Subject: UNABLE TO LOWER REAR SEATBACK WITH REMOTE HANDLE / SEATS HARD TO LOCK	Bulletin No: 09-013/13
	Last Issued: 04/29/2013

- This bulletin supersedes the previous bulletin 09-042/12, issued on 11/07/12. The APPLICABLE MODEL(S)/VINS and REPAIR PROCEDURE have been revised.
- Changes are noted below in Red beside the change bar.

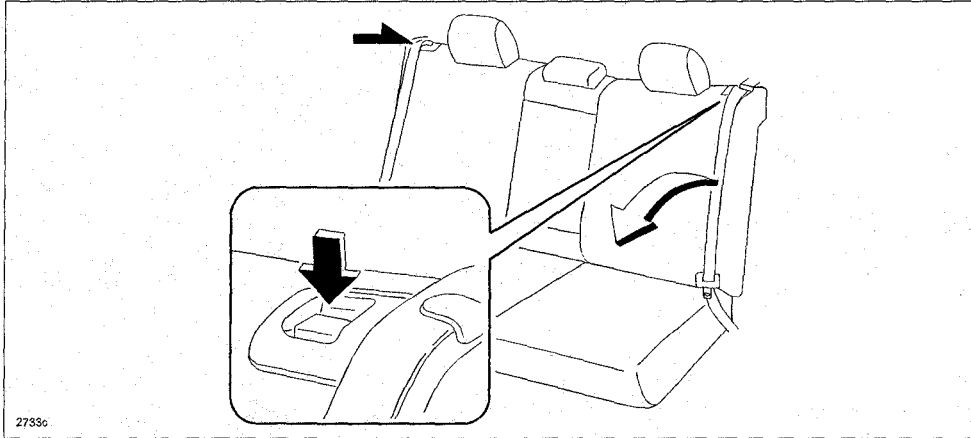
Some vehicles equipped with a 4:2:4 split type rear seat may be unable to lower the rear seatback (A) when pulling the left (B) and/or right (C) remote handles. Also, the seatbacks may not fully latch (lock) when placed in the upright position.

This concern may be caused by an incorrect seatback remote cable adjustment position. The current adjustment position may not provide enough tension for the cable to unlock the seatback latches.

The position of the seatback remote cable adjustment has been changed to the center position at mass-production.

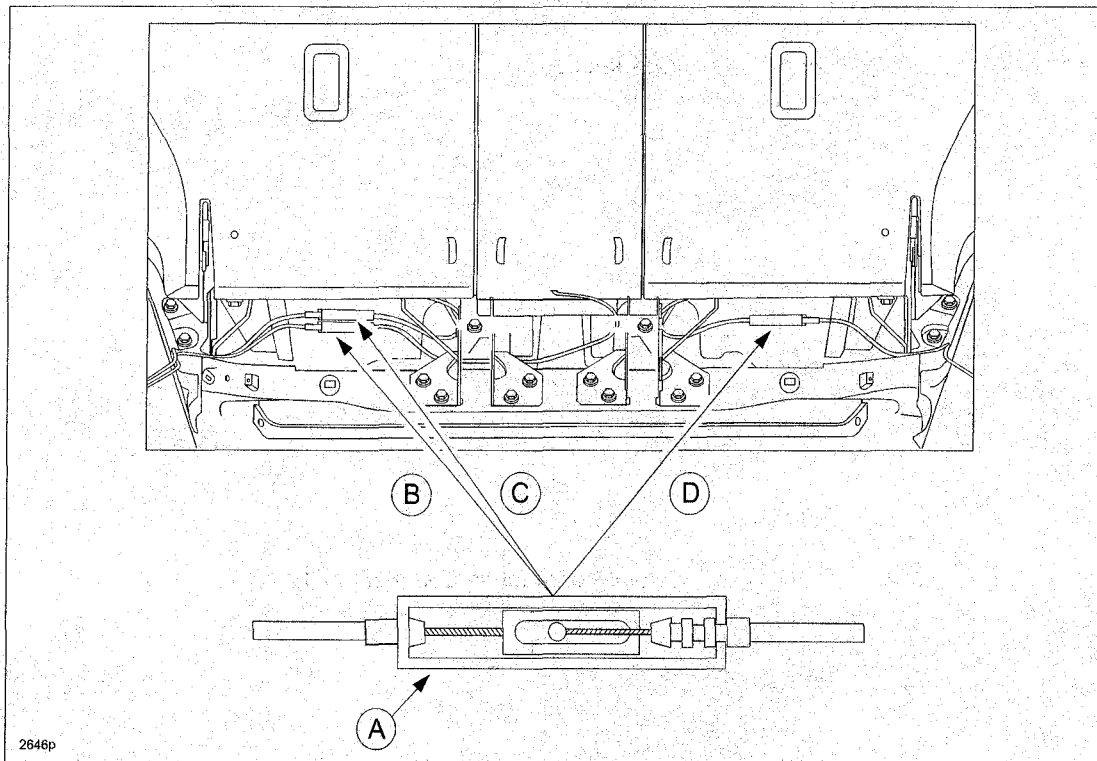
4. Locate the remote cable adjuster (A) for the left seat (B), center seat (C) and right seat (D).

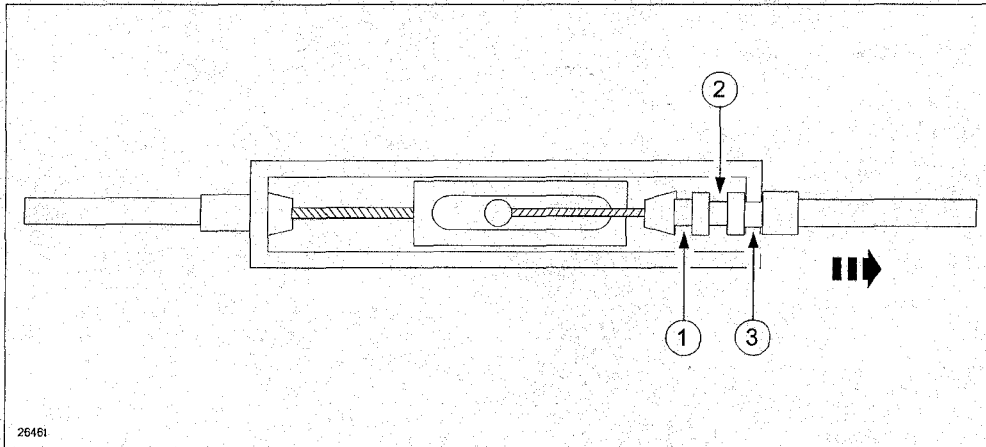
- Using a small flathead screwdriver, pop open the affected remote cable adjuster housing and check the current cable adjustment setting position (1, 2 or 3) as shown below.

NOTE: Cable adjustment setting position "3" is the factory setting for vehicle produced before Feb. 1, 2013.

- Pull the cable out of the housing and change the setting to position "2", then snap the remote cable adjuster housing closed.
- Using the appropriate remote handle lever, check the seat back for proper releasing and locking operation.
